**Rolls-Royce & Bentley
motor cars**

Volume 1

TSD 4446

SERVICE INFORMATION SHEETS INDEX FOR TSD 4446

Fig. 1 Hydraulic damper - Type A

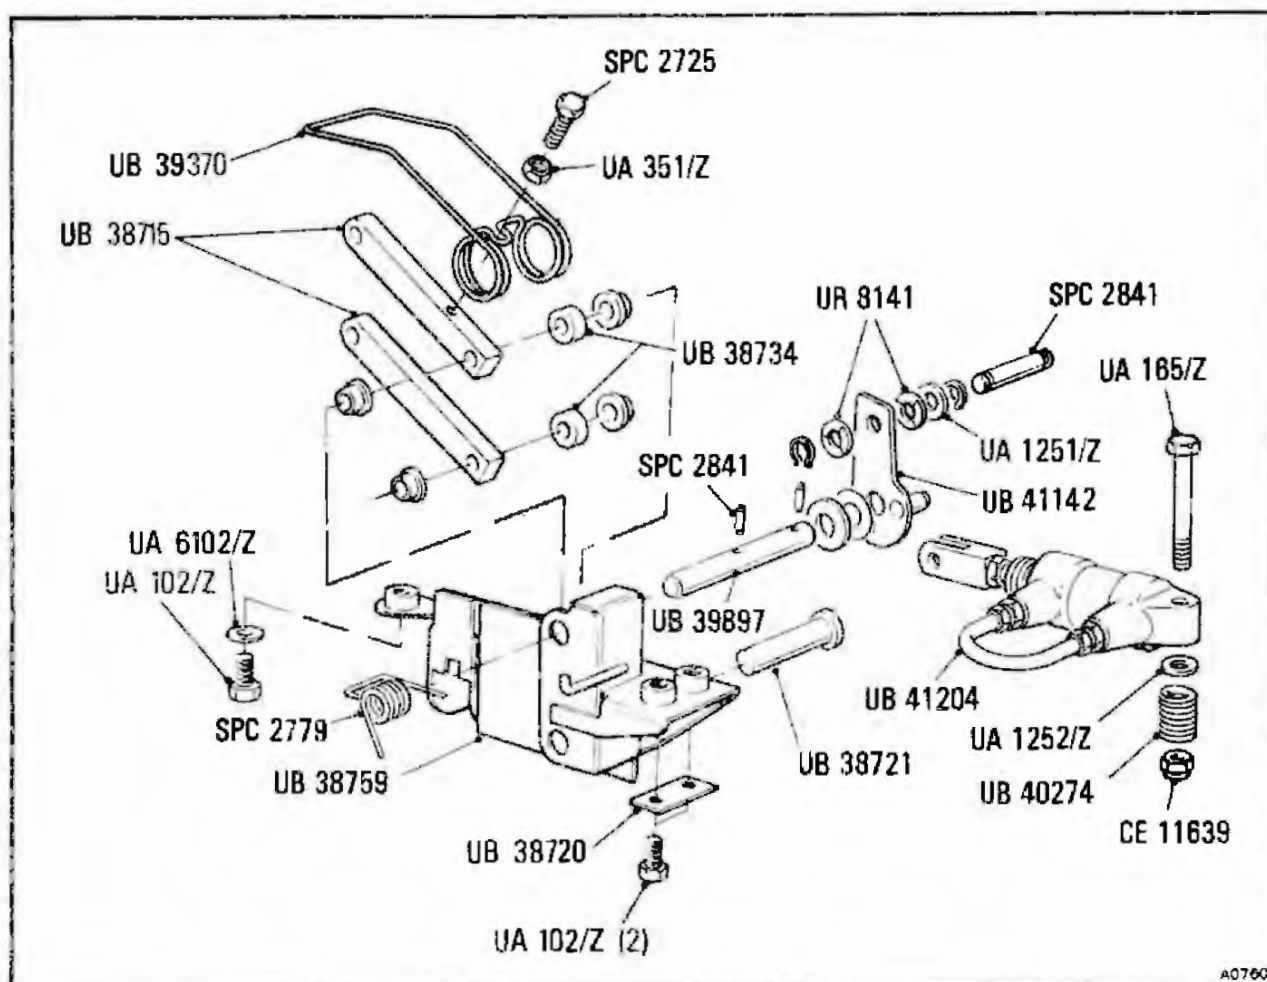
Part Number	Description
UB 41204	- Damper
UB 41142	- Assembly Operating Lever
SPC 2841	- Pin
UB 39897	- Pivot Pin - Upper - Link Arm
UB 40274	- Spring Cylinder Damping
UB 38759	- Assembly Bushing Bracket - Mascot
SPC 2779	- Retract Spring-Mascot
UR 8141	- Washer-Spring Type
UA 1251/Z	- Washer-Mounting Cylinder
UA 1252/Z	- Washer-Pivot Pin
UA 165/Z	- Bolt-Mounting Cylinder
CE 11639	- Nut-Lock Type - Mounting Cylinder

Fig. 2 Gas filled damper - Type B

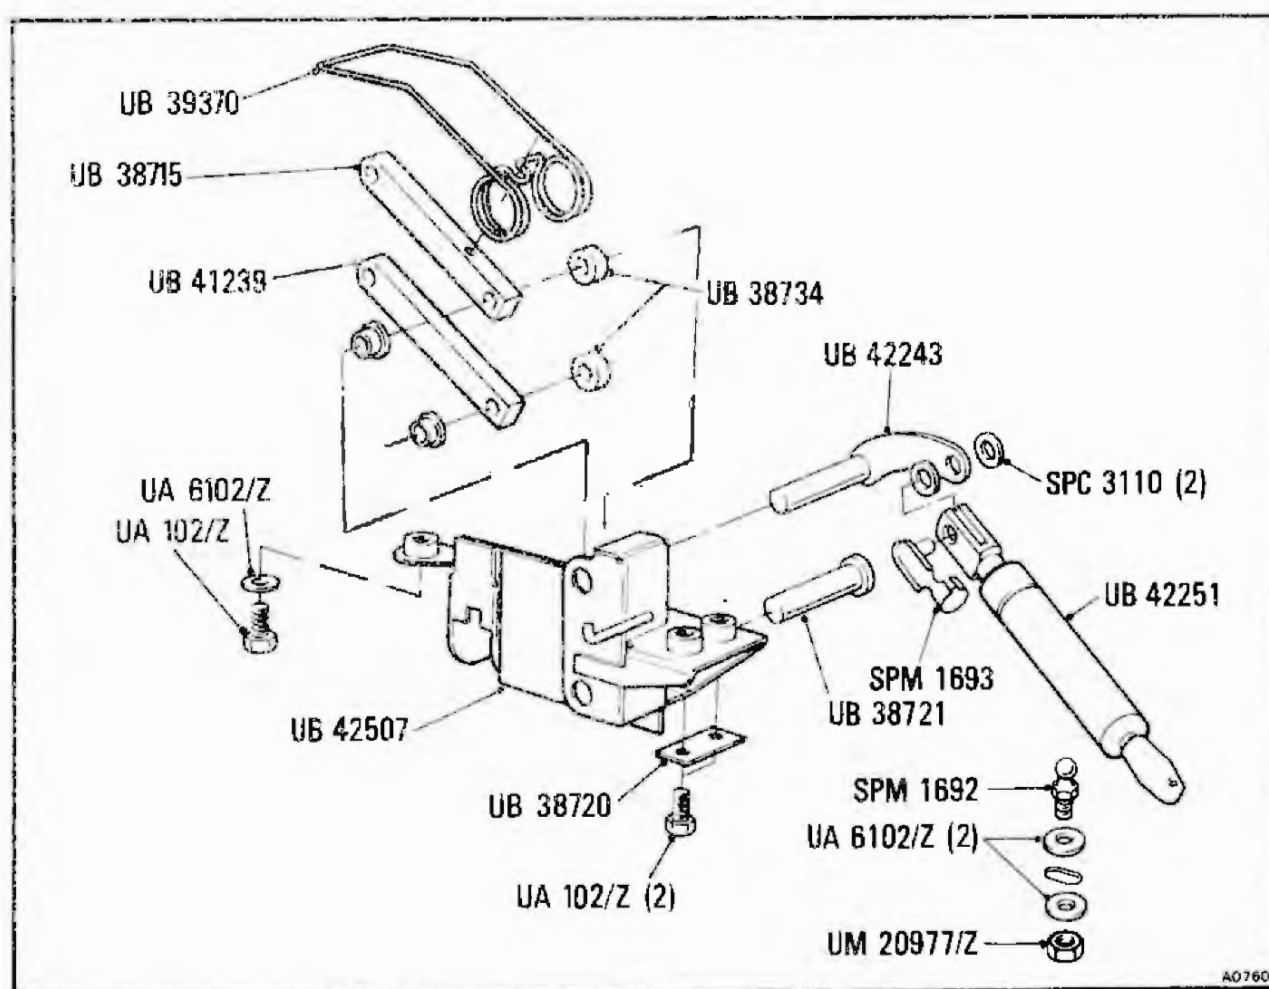
UB 42251	-	Gas Strut
SPM 1693	-	Spring Pin
UB 42243	-	Assembly Operating Lever
UB 42507	-	Assembly Bushing Bracket Mascot
SPC 3110 (2)	-	Nylon Washer
SPM 1692	-	Ball Pin
UA 6102/Z (2)	-	Washer - Ball Pin
UM 20977/Z	-	Nut - Ball Pin
